Construction Division
Additions & Alteration Charges Approval Form

Company Name:		MRMLP		Site	Gulmohar Residency
Name of the customer		V. Srinivas.			
Villa/ Flat No.		H-207.

GULMOHAR RESIDENCY

Details of Additions & Alterations

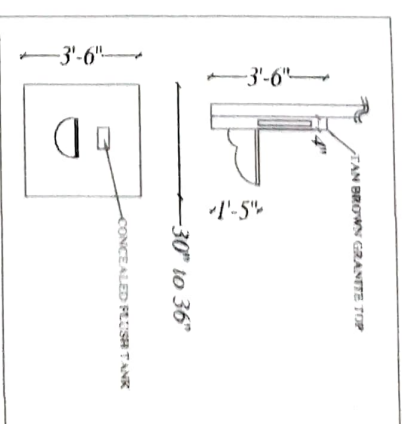
Goods room stored at children bed room (LH wall)
